RE: **Site Plan Review (SPA 23-0001)** for the construction of a 22,484-square foot multi-tenant commercial building, with associated parking and site improvements. The applicant is requesting waivers to the landscaping standards and parking stall size. Site location is 7749 E M-36; TID 15-25-200-068.

**To:** Planning Commissioners  
**From:** Amy Steffens, AICP  
Planning and Zoning Director  
**Date:** May 31, 2023

**Project address and Description:** **Site Plan Review (SPA 23-0001)** for the construction of a 27,461 multi-tenant commercial building, with associated parking and site improvements. The applicant is requesting waivers to the landscaping standards. Site location 7749 E M-36; TID 15-25-200-068.

M-36 ZANDER BUILDING PHOTOMETRIC CALCULATION  
HAMBURG, MICHIGAN

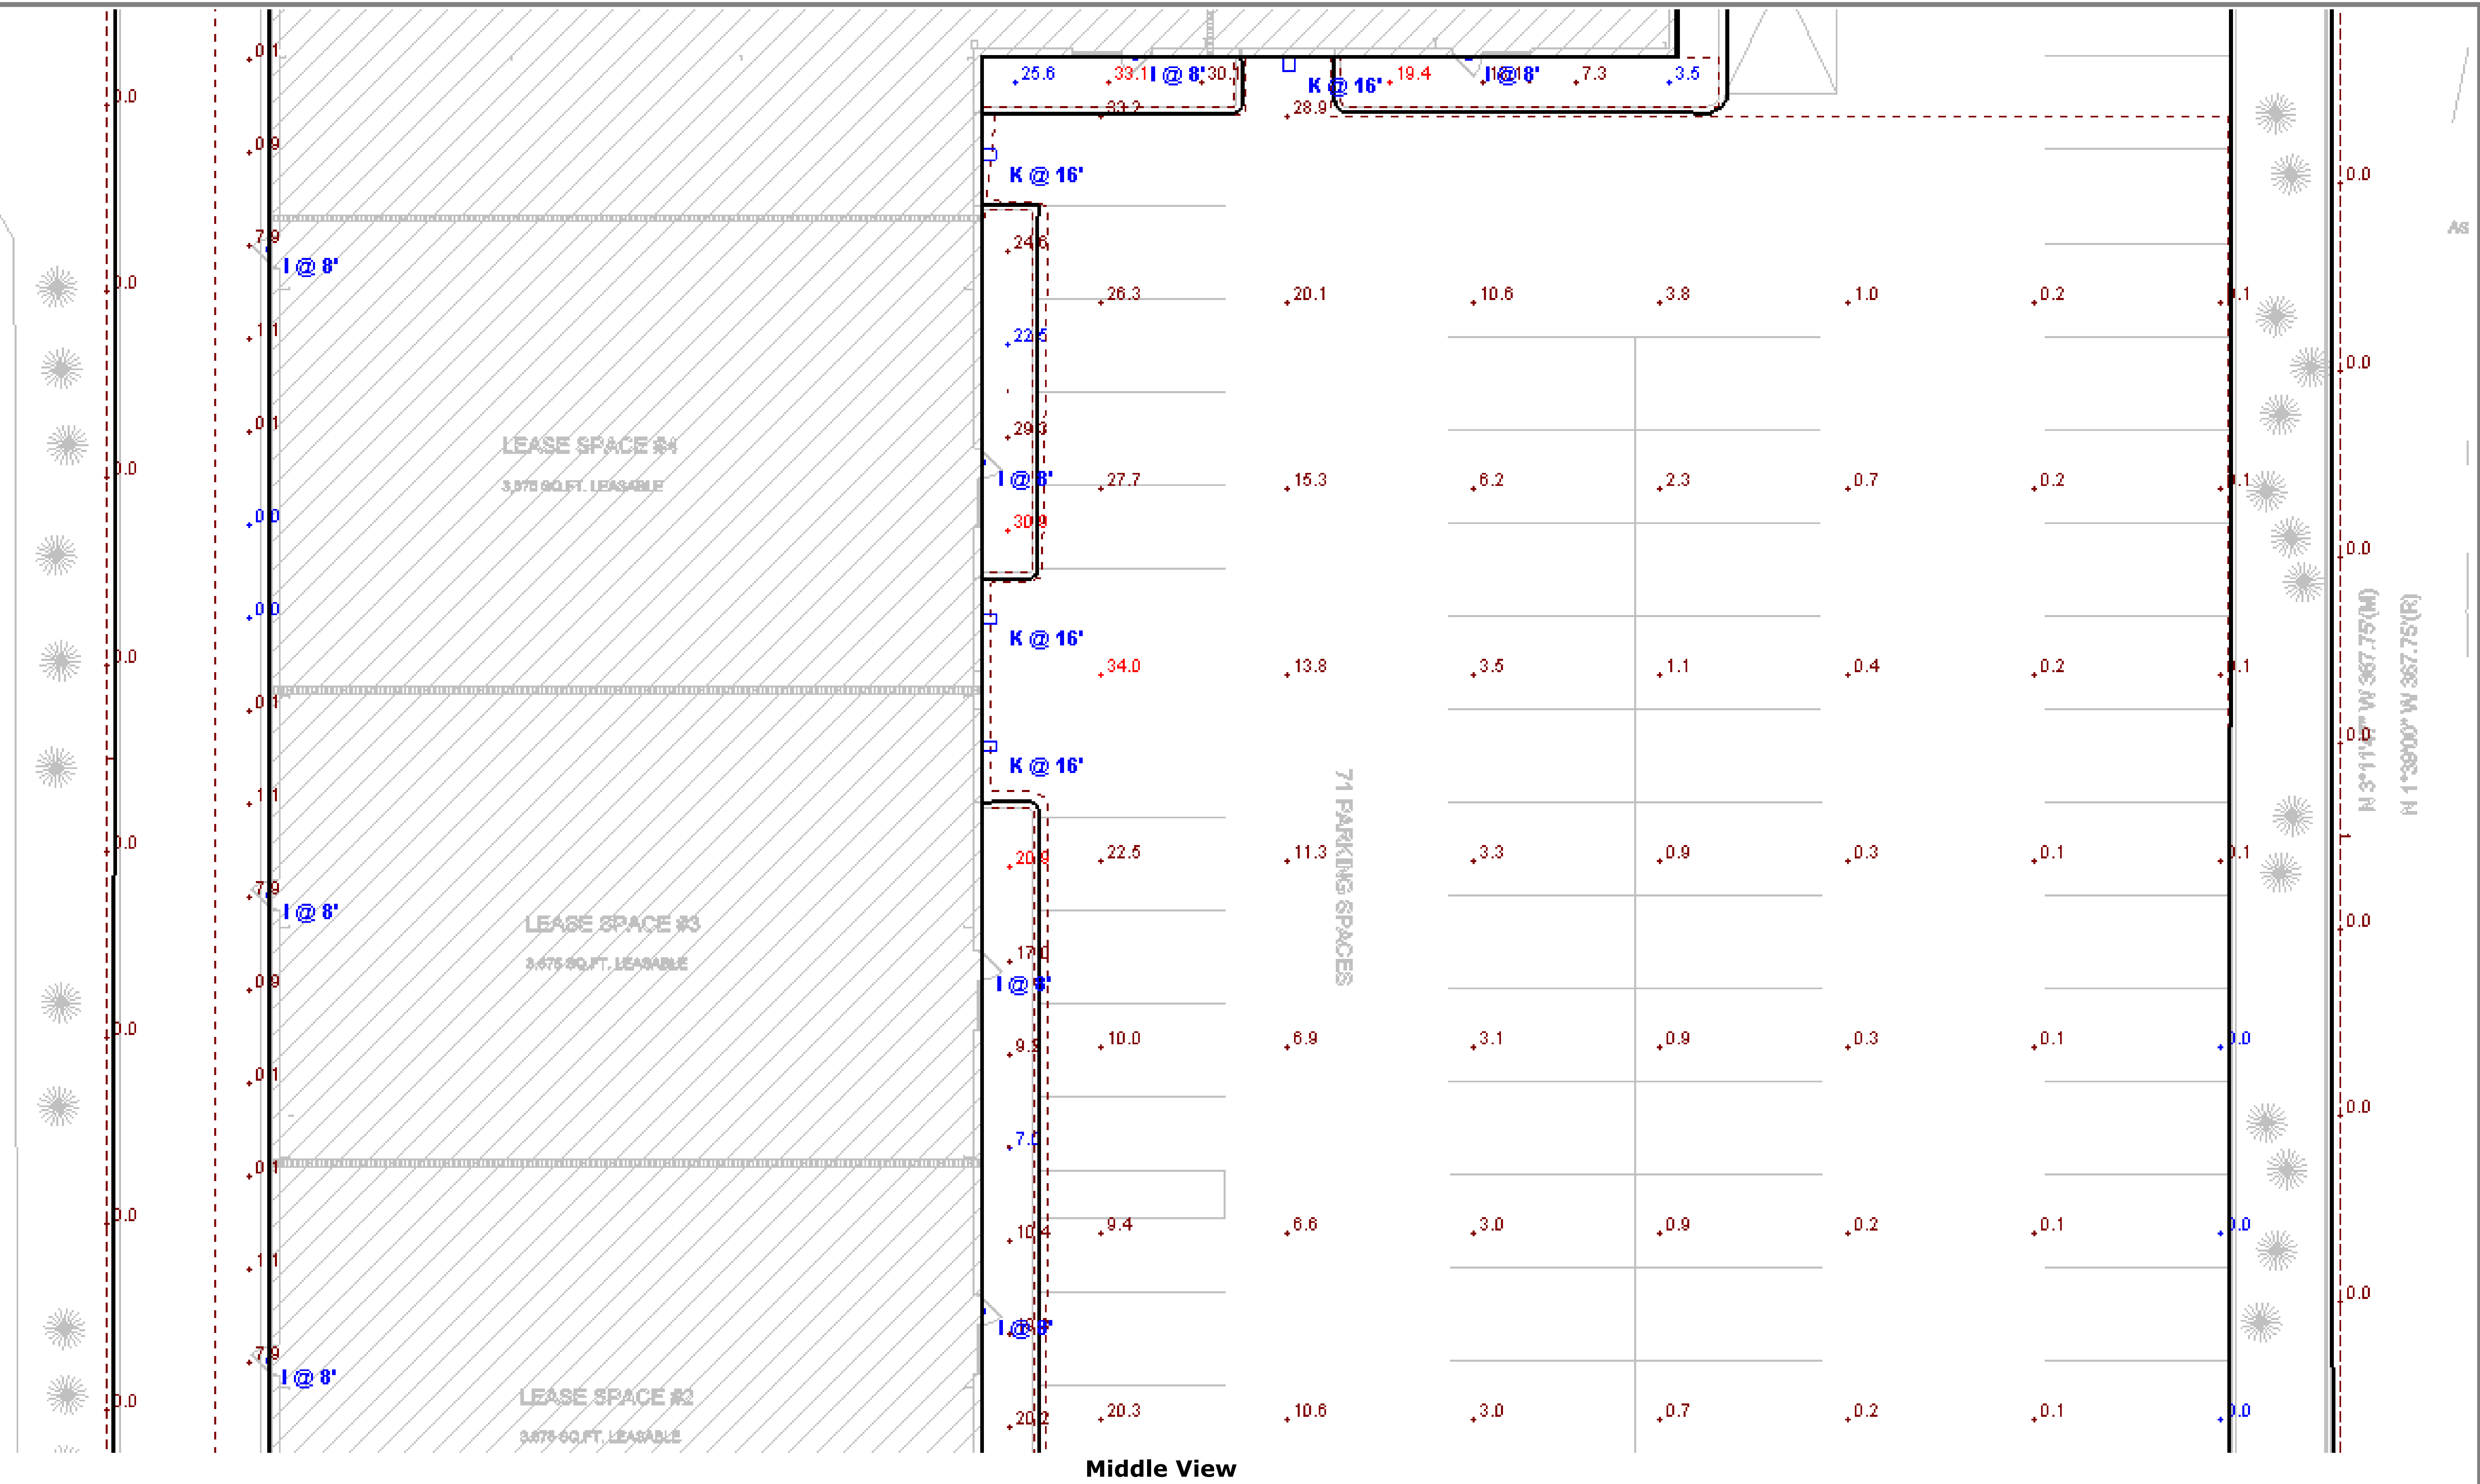
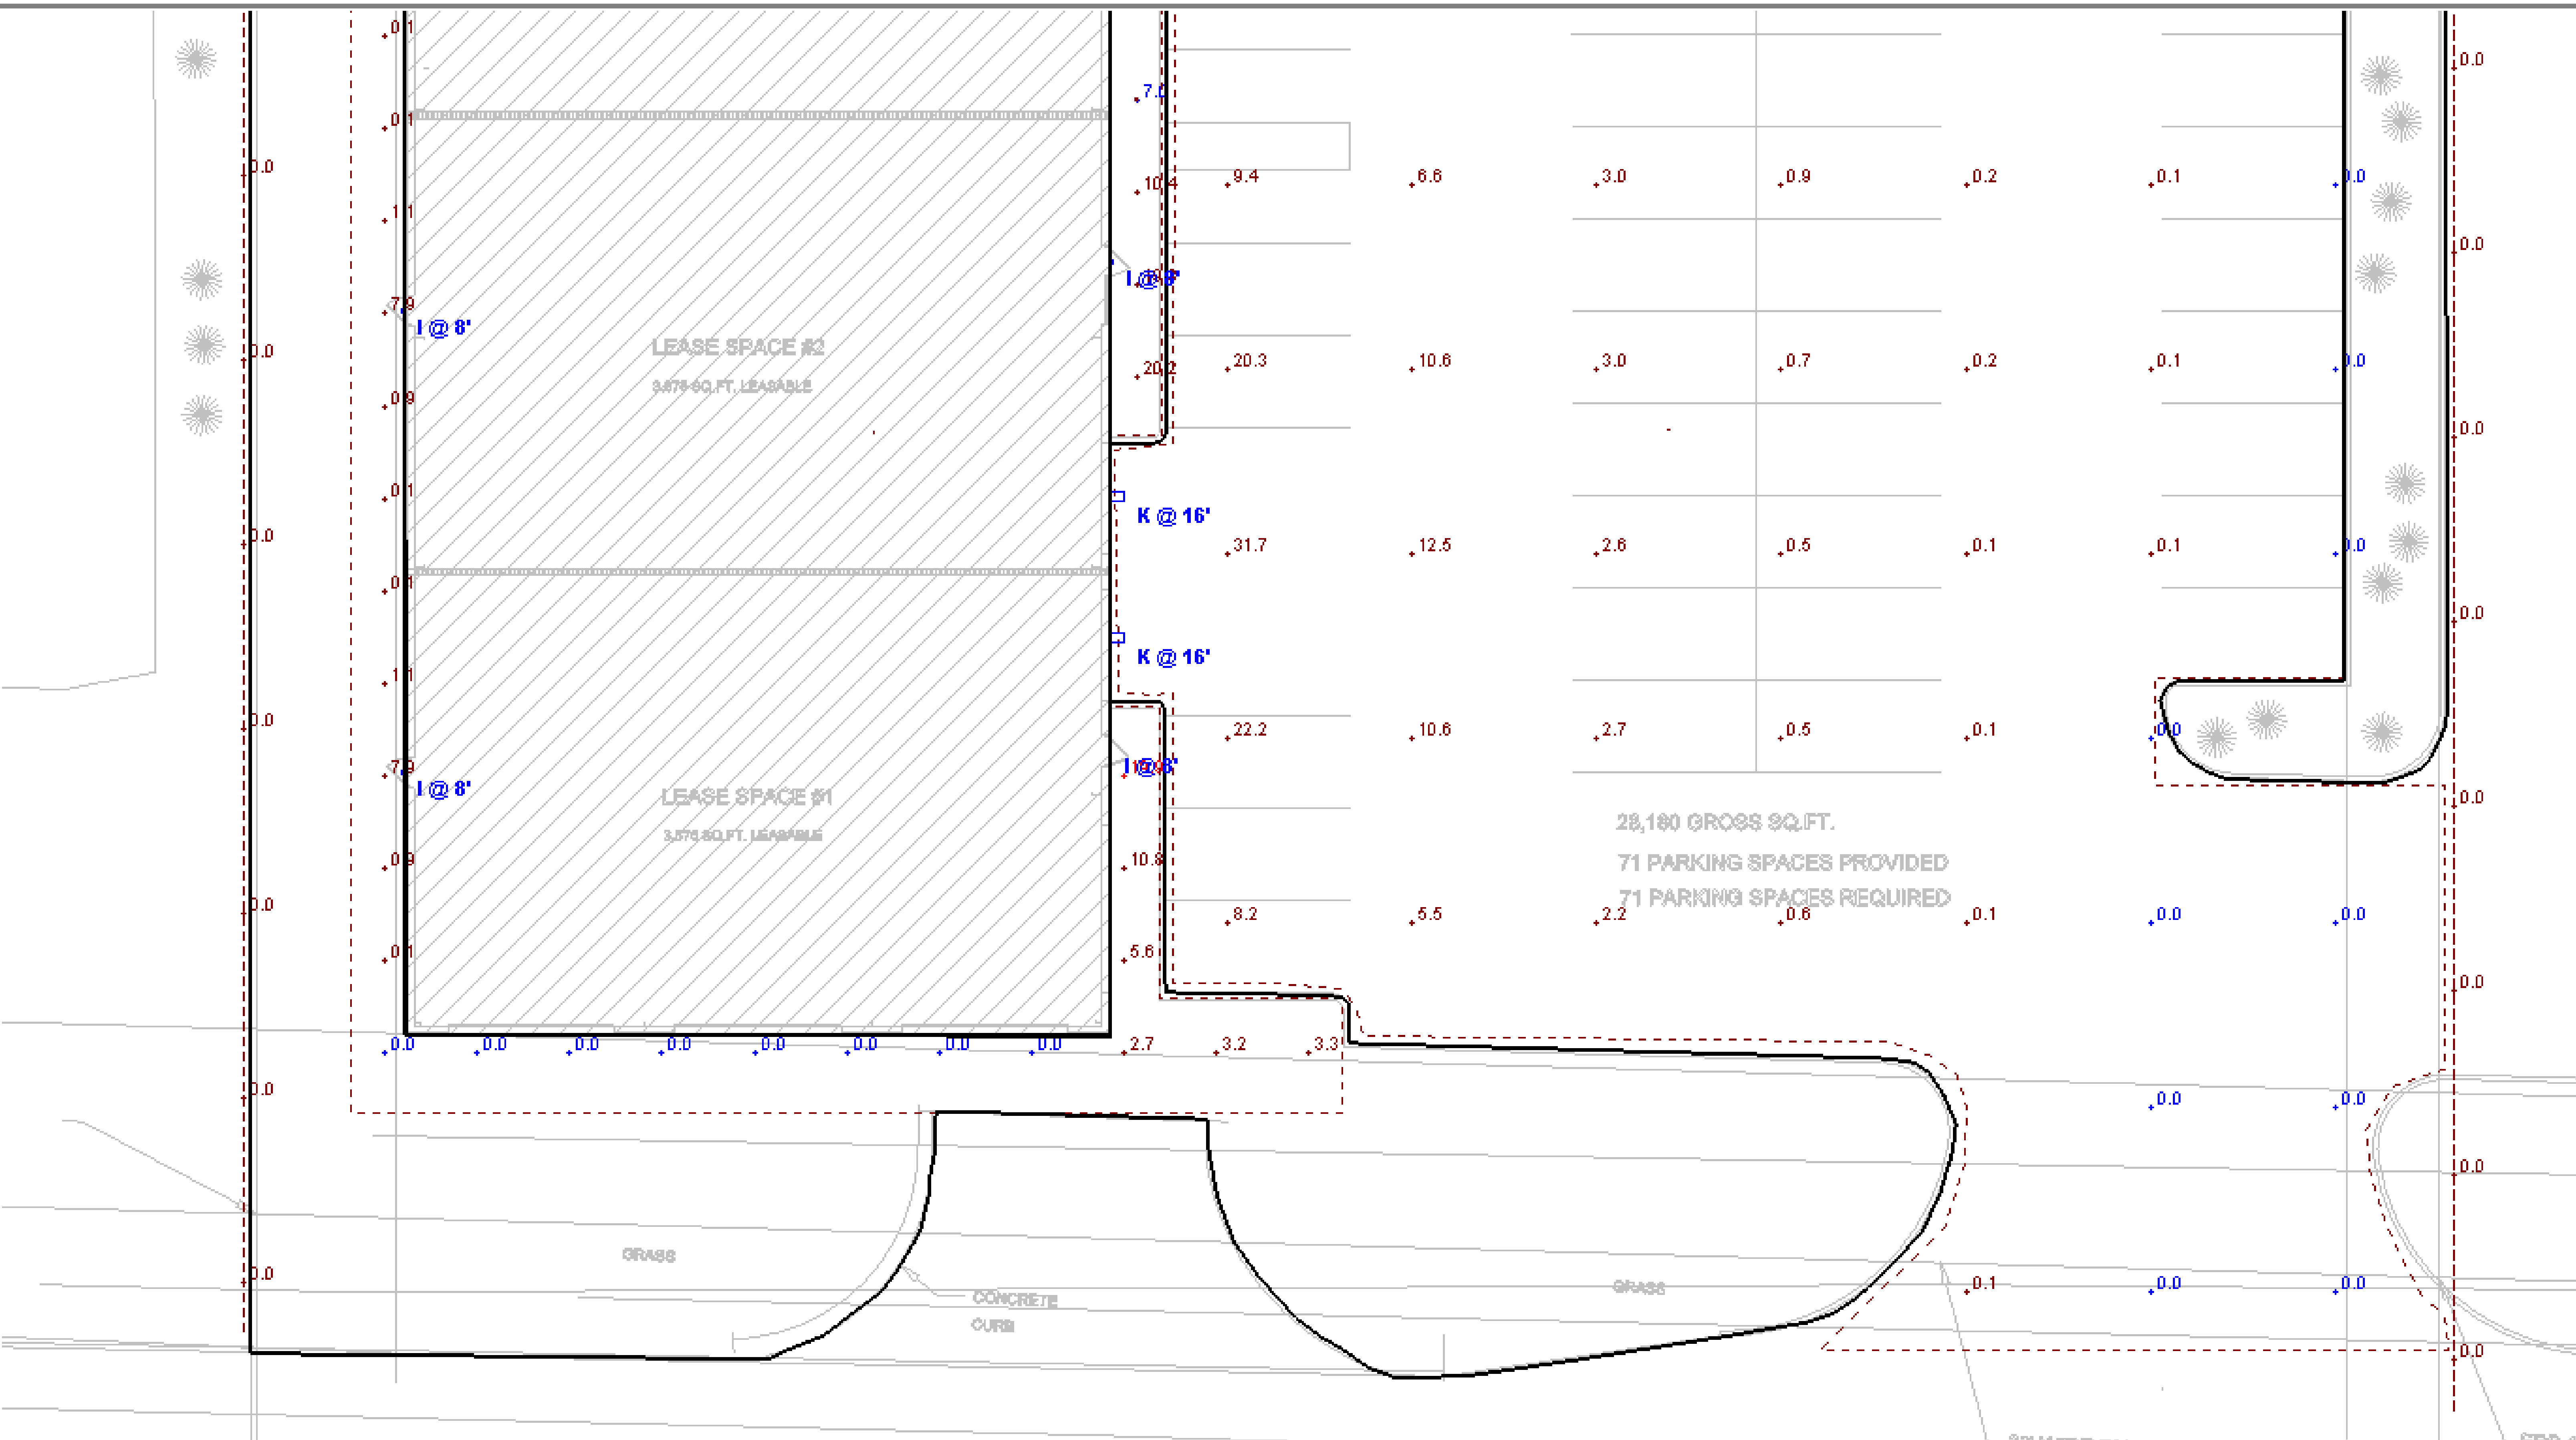
**Staff analysis:** The site plan does not include lighting along the pedestrian path on M-36 or within the parking lot.

**Staff suggested condition:** Final site plan shall indicate required lighting along M-36 pathway and parking area. Light fixtures to match approved Village Center fixtures and shall comply with light intensity requirements.
